7 Individual Community Submissions

7.1 Communication

Figure 8.1 Preferred alignment at Bella Vista Station (station box parallel to Old Windsor Road)

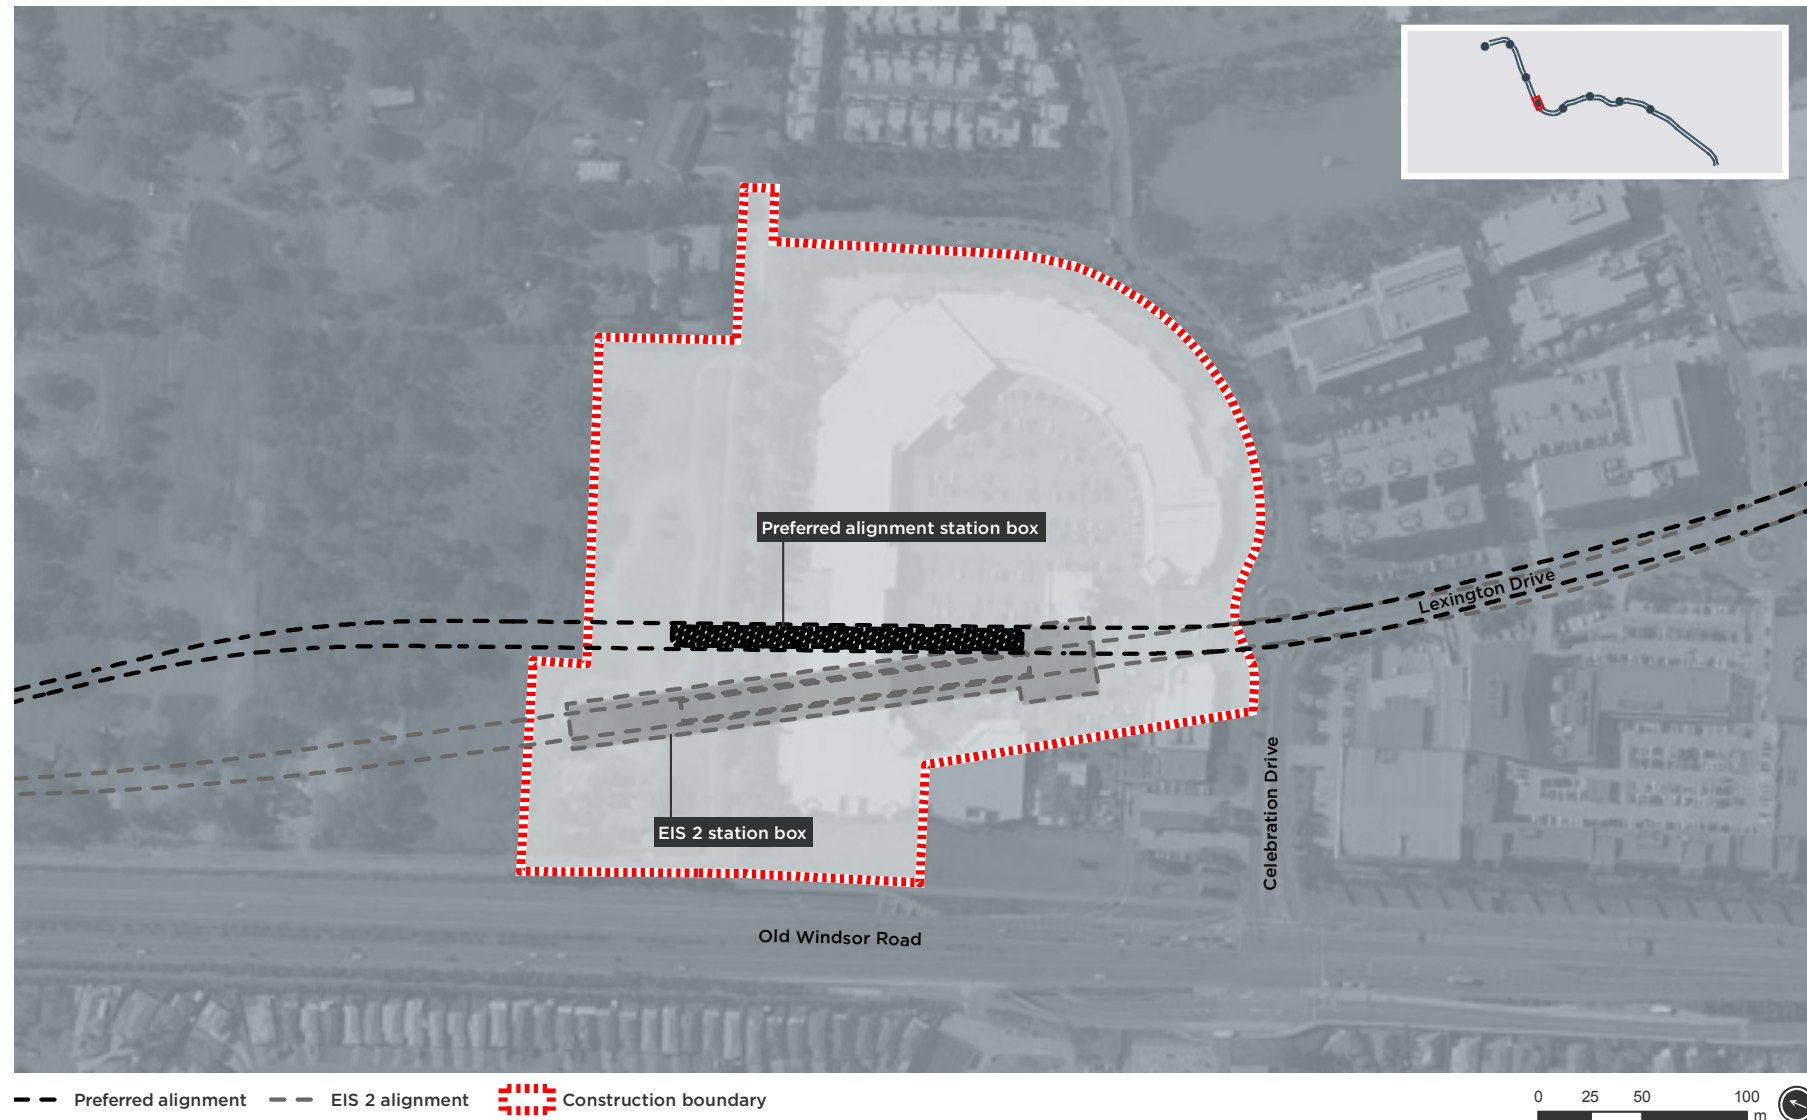
In particular the preferred design, as shown on Figure 81 and Figure 82, includes:

The modifications to the layout and alignment at Bella Vista Station would result in a number of benefits including:

- ❖ An improved station precinct with better circulation and access to station facilities, commuter car parks and residual land.
- ❖ Mitigation of existing and forecast delays at key intersections by increasing capacity at and in the vicinity of the Celebration Drive / Lexington Drive intersection.
- ❖ Improved access arrangements for surrounding local businesses, in particular the McDonald's and BP service station, resulting from the maintenance of the existing access and car park facilities for these two businesses.
- ❖ Potential for early station precinct activation and future development opportunities between the station alignment and Old Windsor Road.
